SUPPLEMENTAL BID BULLETIN NO. 2
22 May 2025

Supply, Delivery, Installation, and Configuration of Server Room Security and Management Project for the Presidential Communications Office (PCO)
[Procurement/Contract No. 2025-04-041]

ANNEX A

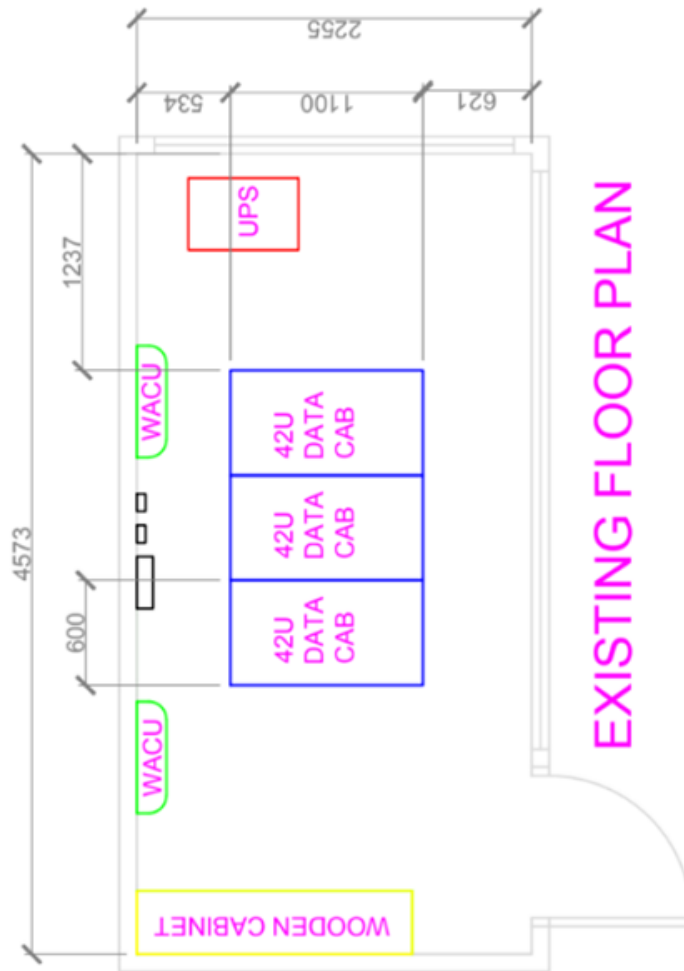
CLARIFICATION	ANSWER
A.1 Precision Air Conditioning Unit	One (1)
1. Clarification for the quantity of precision air conditioning unit	
2. Can you provide the as-built plan of the data center, including the electrical?	Yes (please see Annex A).
